STAFF REPORT
KETCHUM PLANNING AND ZONING COMMISSION
REGULAR MEETING OF MARCH 18, 2026

PROJECT:	680 N Leadville Ave Multi-Family Development
APPLICATION TYPE:	Preapplication Design Review (File No. P25-062)
PROPERTY OWNER:	Plumbum, LLC
REPRESENTATIVE:	Brenda Moczygema, AIA, Williams Partners Architects
REQUEST:	Preapplication Design Review for the development of a new 10-unit multi-family residential building
LOCATION:	680 N Leadville Ave (Ketchum Townsite: Block 27: Lots 3 & 4)
ZONING:	Mixed-Use Subdistrict of the Community Core (CC-2 Zone)
REVIEWER:	Abby Rivin - Senior Planner
NOTICE:	A courtesy notice for the public meeting was mailed to all owners of property within 300 feet of the project site and all political subdivisions on February 25, 2026. The public meeting notice was published in the Idaho Mountain Express on February 25, 2026. A notice was posted on the City's website on March 3, 2026 and on the project site on March 11, 2026. Public comment received prior to publication of the staff report is included as Attachment E.

SHEET NO.
C0.3

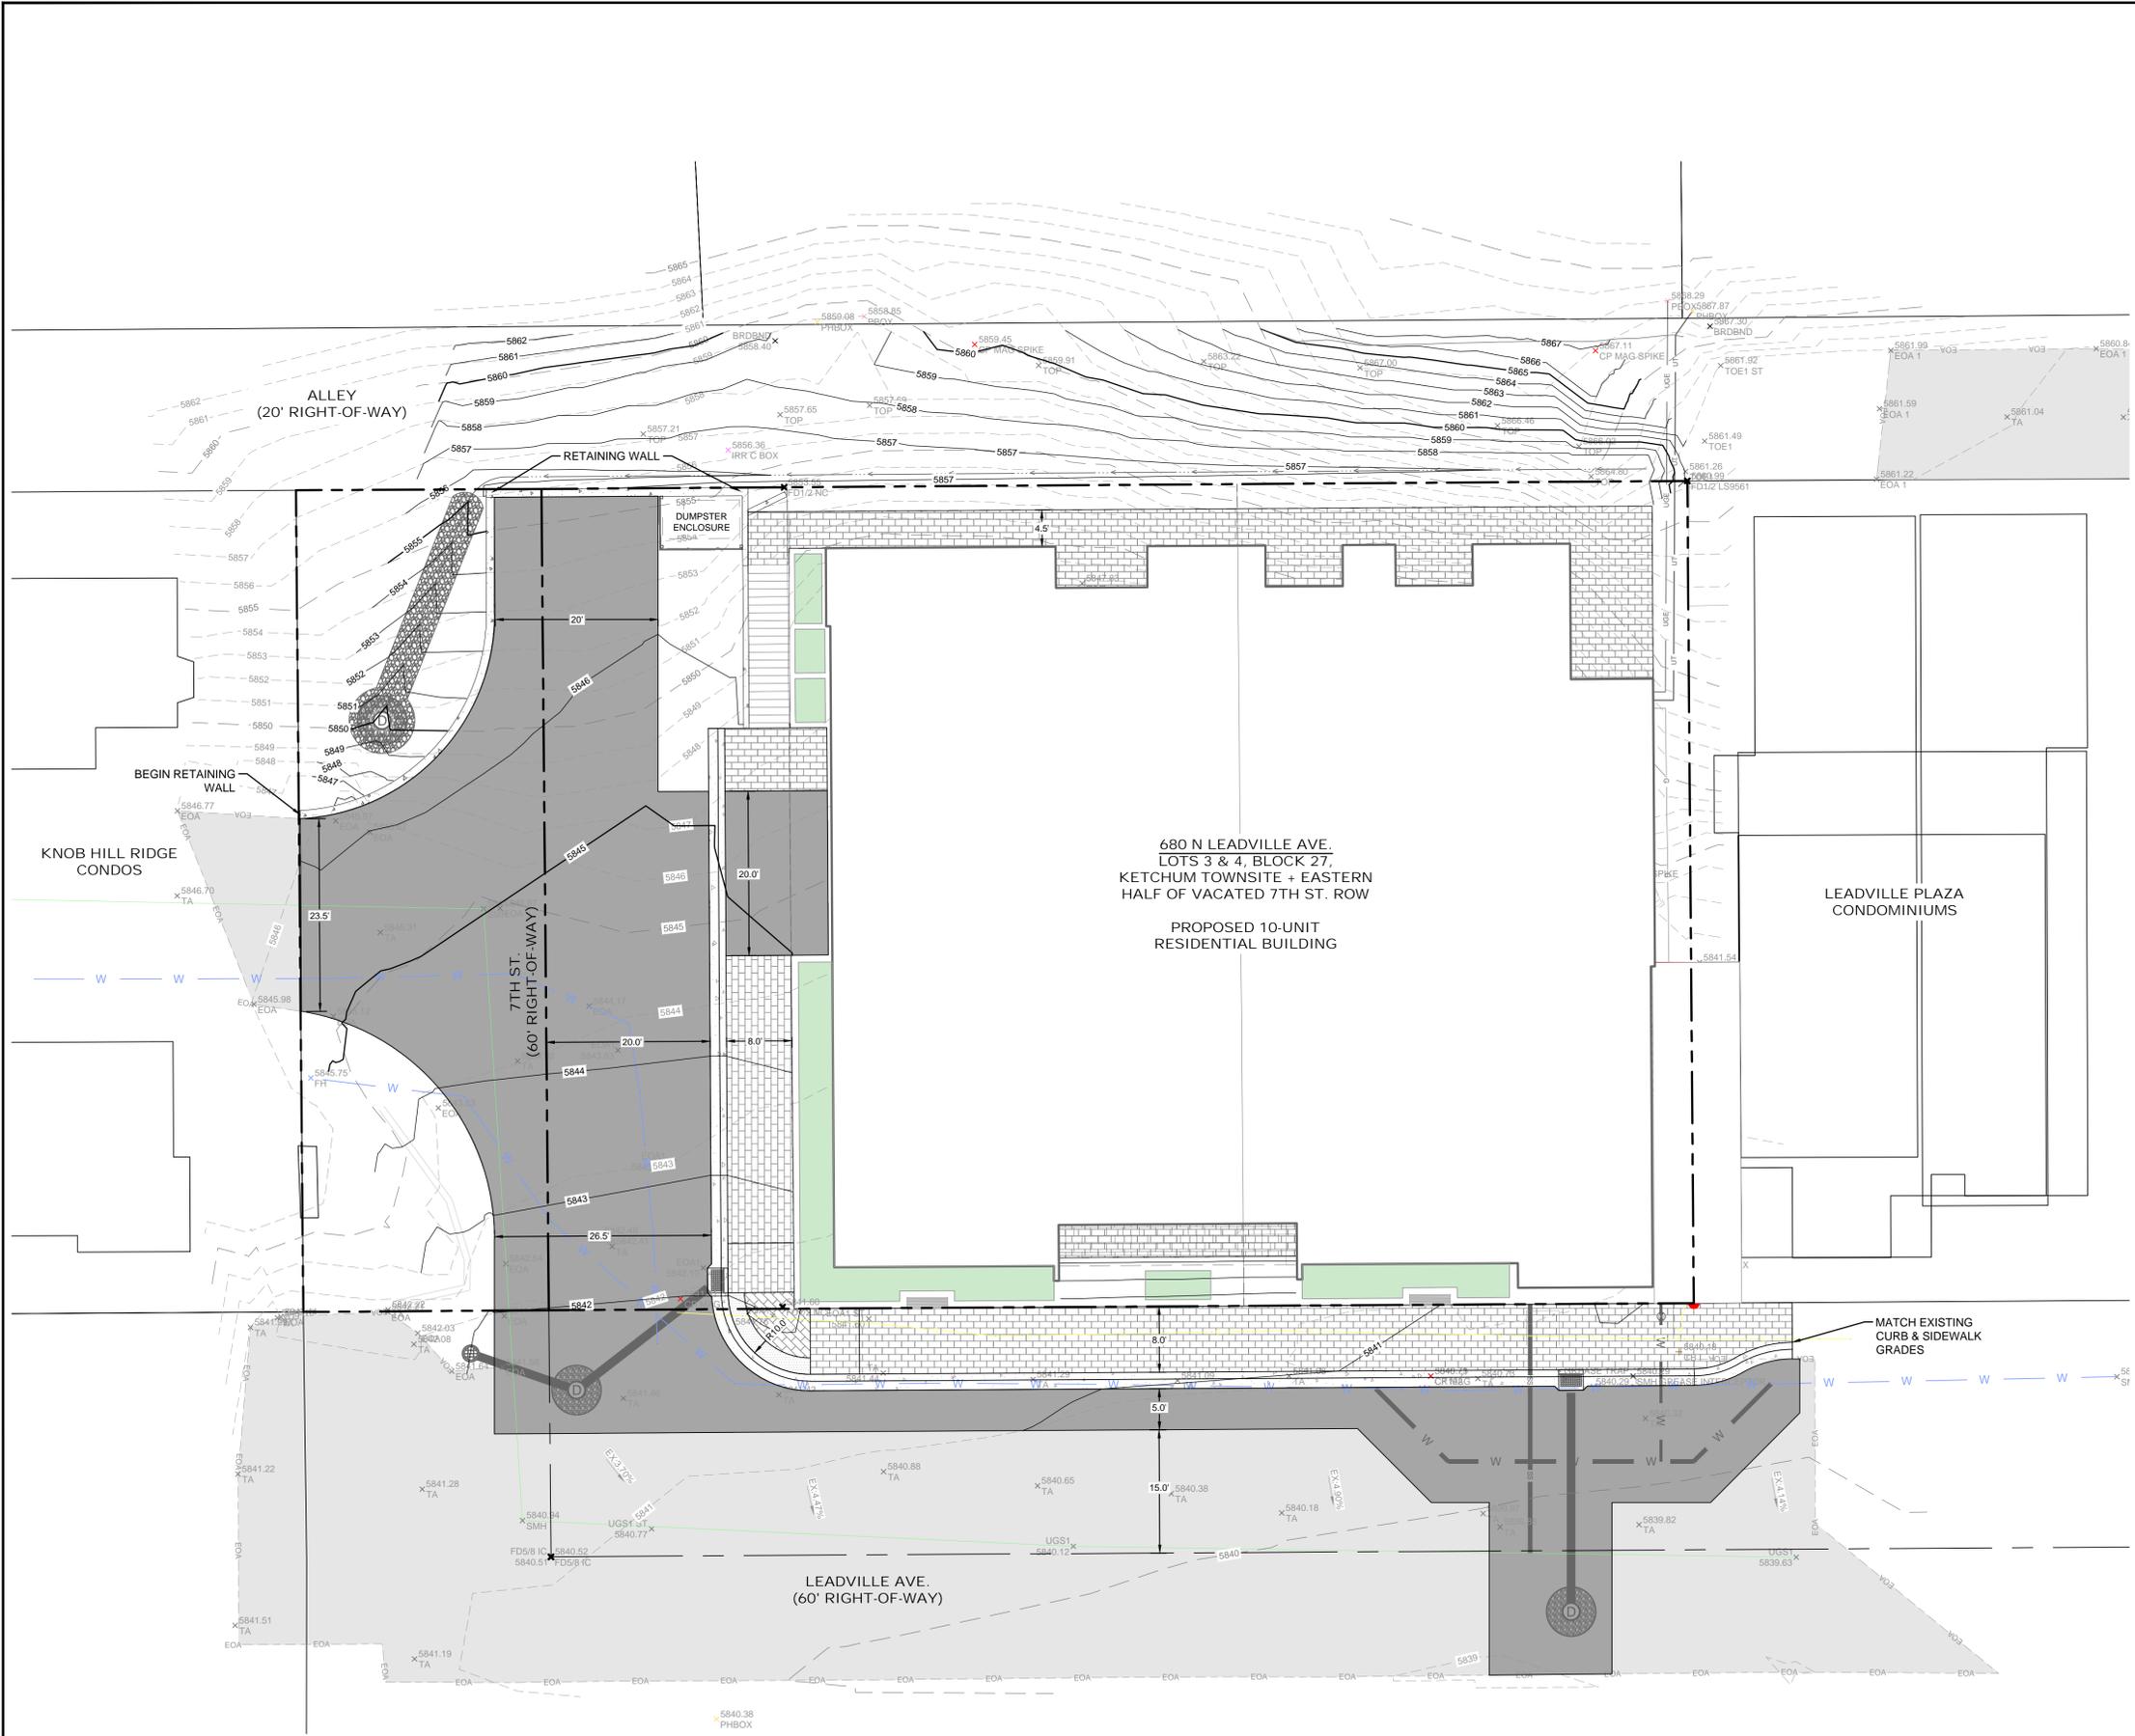
Lots 3 and 4, together with the vacated portion of the 7th Street ROW, are proposed to be consolidated to accommodate the development (see Figure 1). The portion of the 7th Street ROW proposed for vacation is not currently maintained by the City and is improved with an asphalt driveway that provides access to the Knob Hill Ridge Condominiums. This portion of the ROW is not improved to City standards and functions as a private driveway rather than a public street. The

consolidated parcel, including Lots 3 and 4 and the vacated portion of the 7th Street ROW, would total 13,997 square feet and would provide 140 feet of frontage along Leadville Avenue.

FIRST FLOOR PLAN
SCALE: 1/8" = 1'-0"

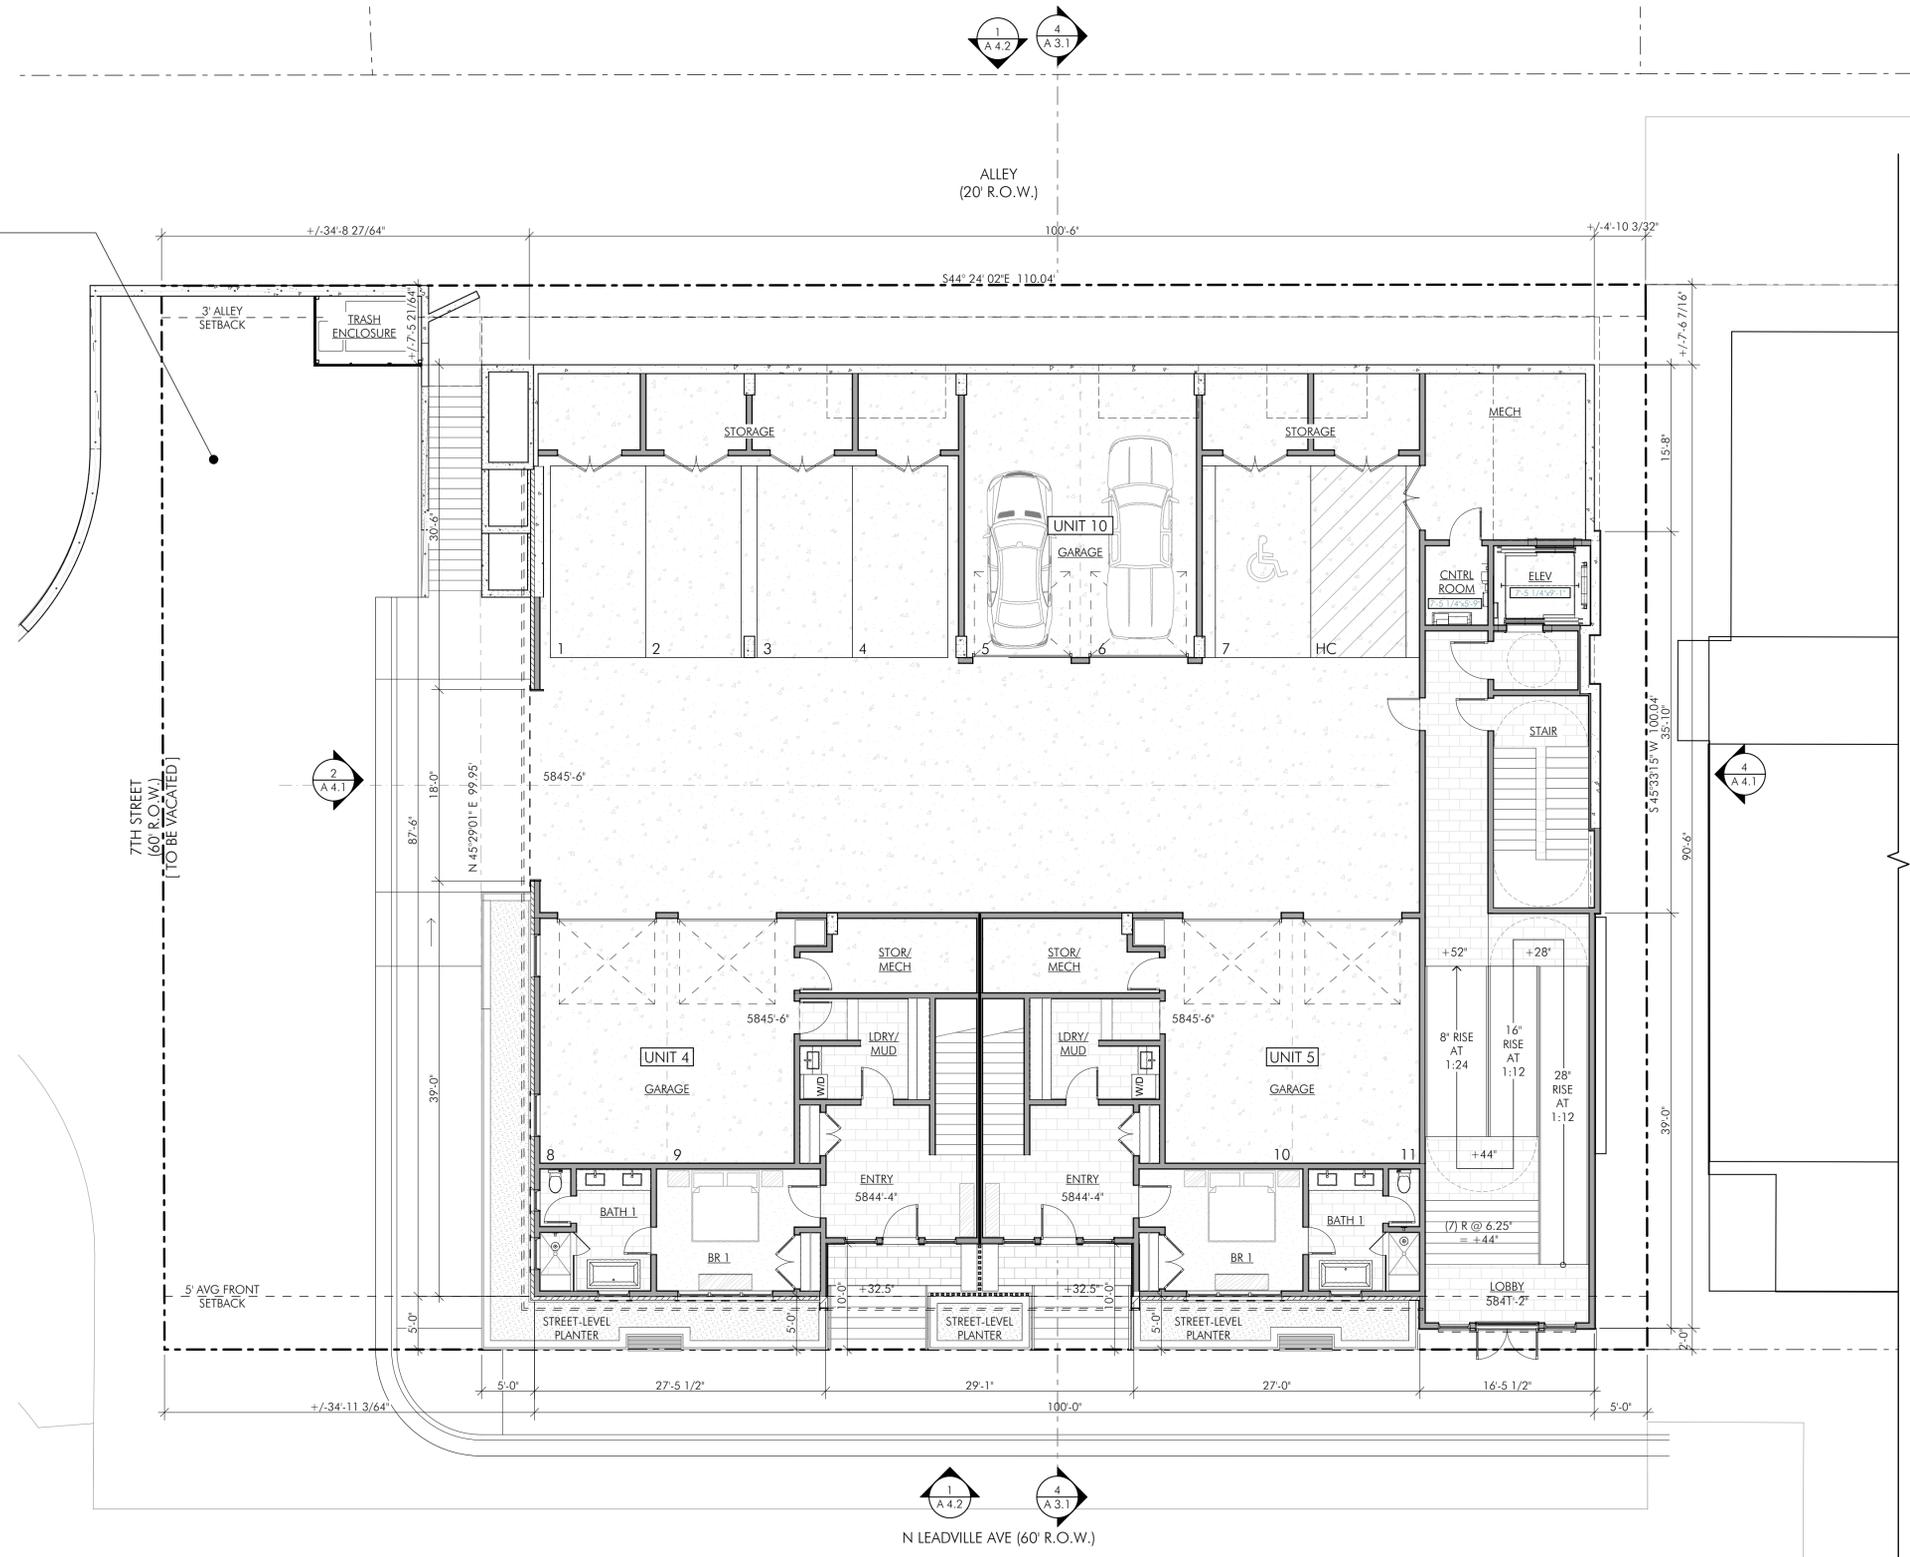
8. *Parking Stall & Aisle Width Dimensions*—The first-floor plan on Sheet A2.1 shows 11 off-street parking spaces; however, the dimensions of the stalls and drive aisle are not provided. Pursuant to KMC §17.125.030.A, 90-degree parking spaces must be 9 feet wide by 18 feet long, with a 24-foot-wide drive aisle. Please specify the parking stall and aisle dimensions on the project plans submitted with the final Design Review application.

9. *ADA Parking Space*—Pursuant to KMC §17.125.030.A, ADA parking spaces must meet the dimensional requirements outlined in the current ADA Standards for Accessible Design. The parking garage plan on Sheet A2.1 does not show a designated ADA space. Please designate an ADA parking space and provide dimensions that comply with the current ADA standards.

A 2.4
FLOOR PLANS

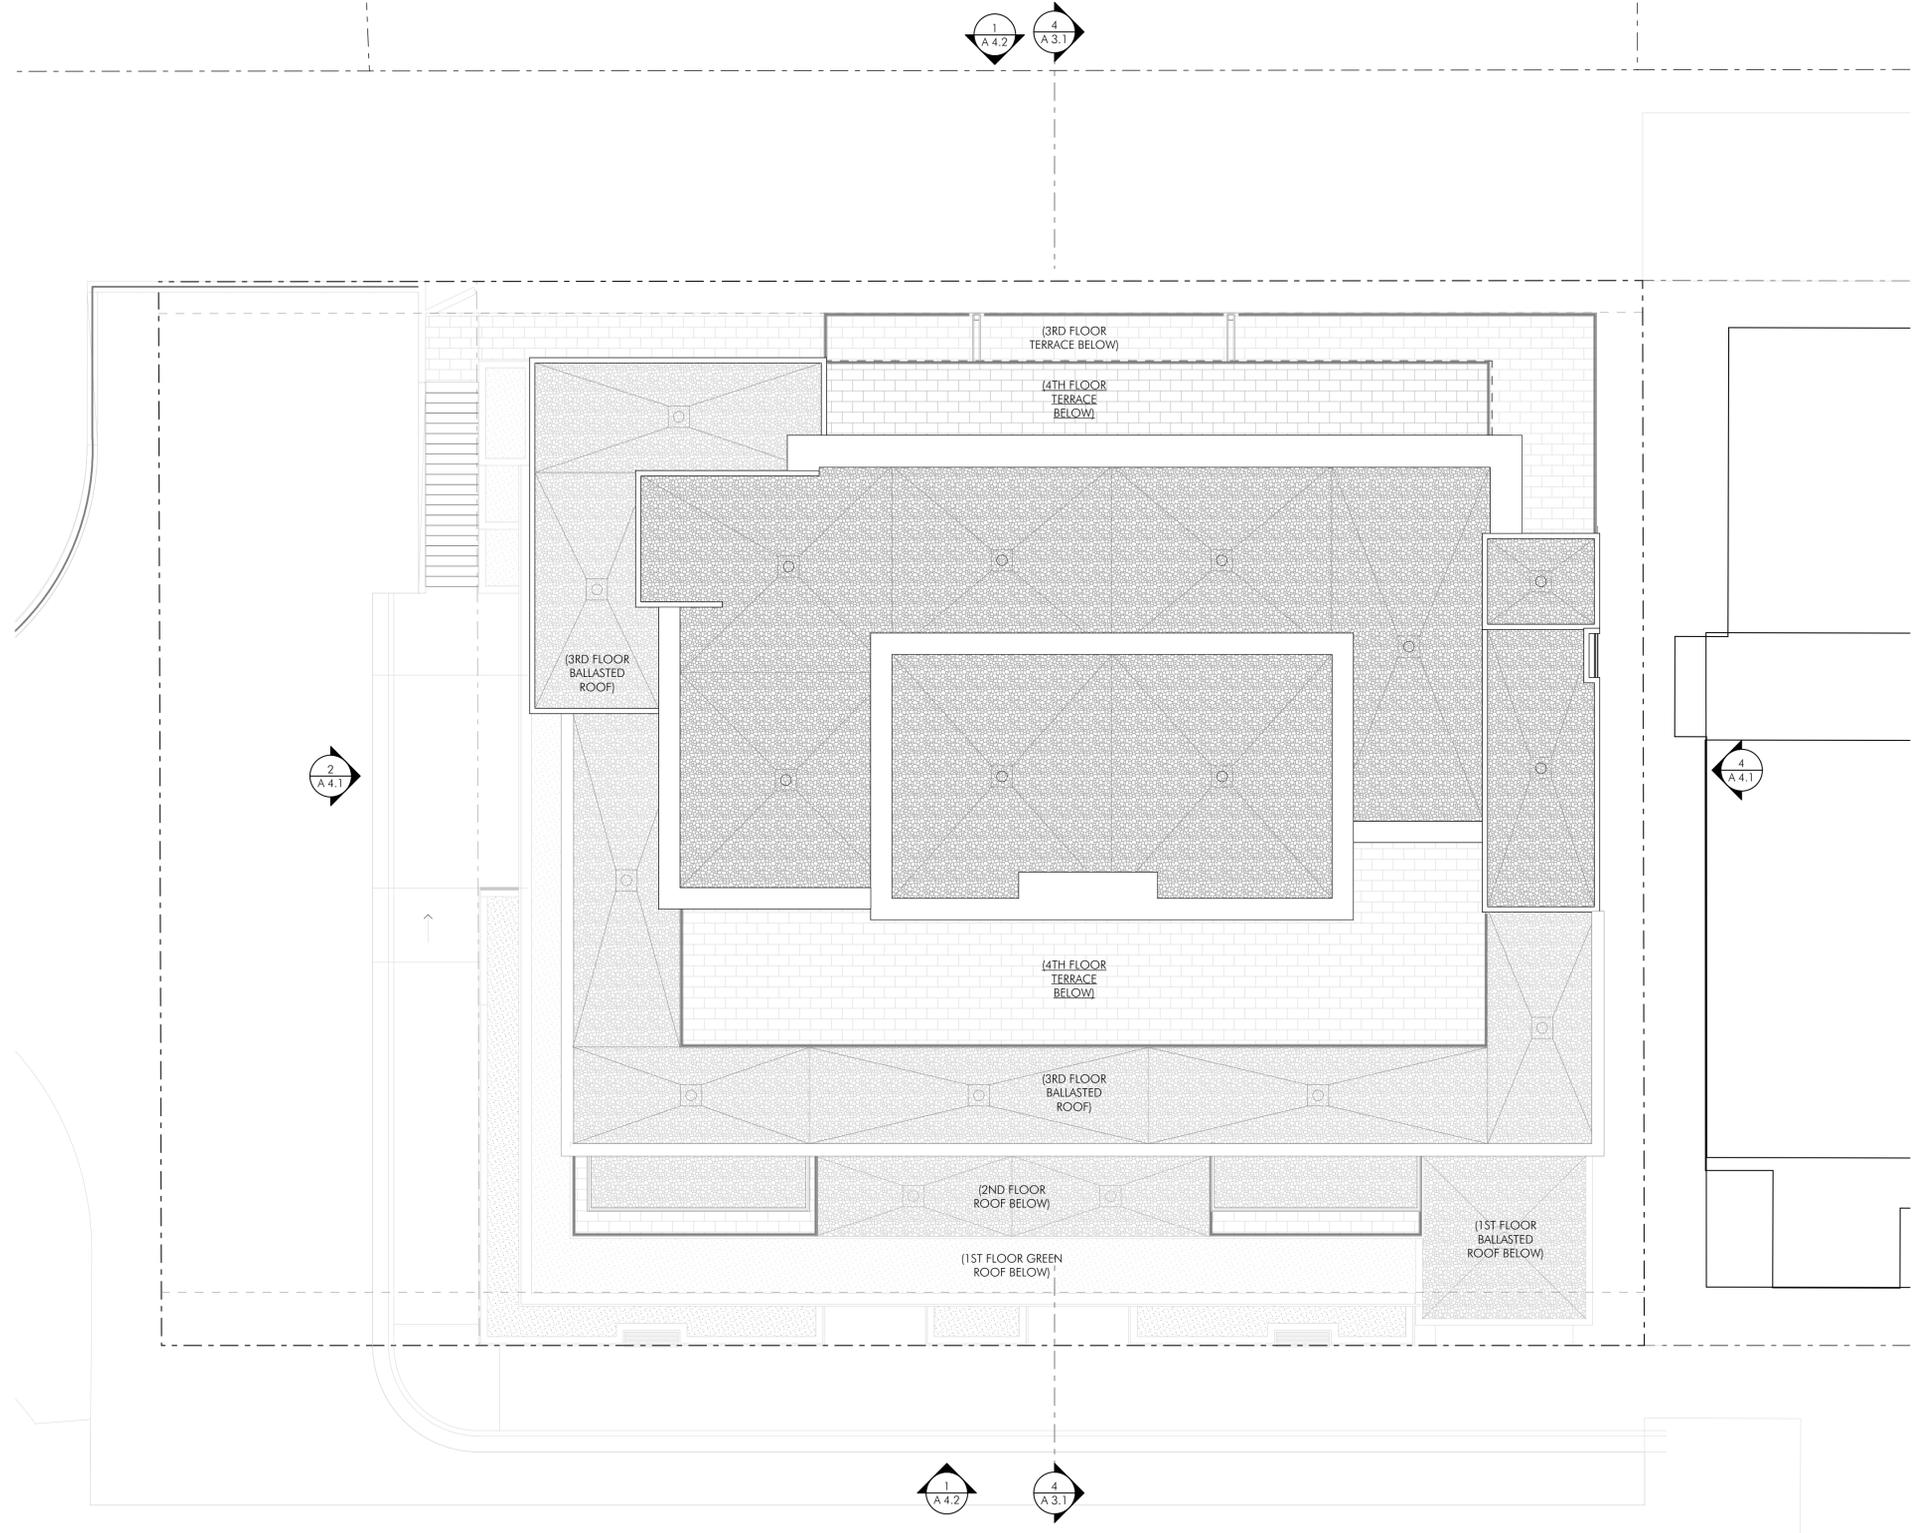
Staff requests Commission direction on whether the stair and elevator encroachment into the fourth-floor setback is appropriate in this location, or whether the applicant should revise the fourth-floor design to fully comply with the 10-foot setback requirement.

7. *Fourth Floor Setback*— Per KMC §17.12.040, the fourth floor must be set back 10 feet from all building facades. While the fourth-floor plan on Sheet A2.4 shows this setback, the elevator, stairwell, and lobby areas at the south side and northeast corner encroach into the required 10-foot setback. The entire fourth floor, including these vertical circulation areas, must comply with the 10-foot minimum setback. The fourth-floor plan must be revised accordingly.

“This area is not visible, as it sits along a 10-foot gap between the existing Leadville Plaza and proposed structure on the interior property line, 41 feet back from the front property line. The basement invisible plane also captures the lower floor of the stair and elevator, as the grade rises an average of 17.5 feet from the front to rear property line.”
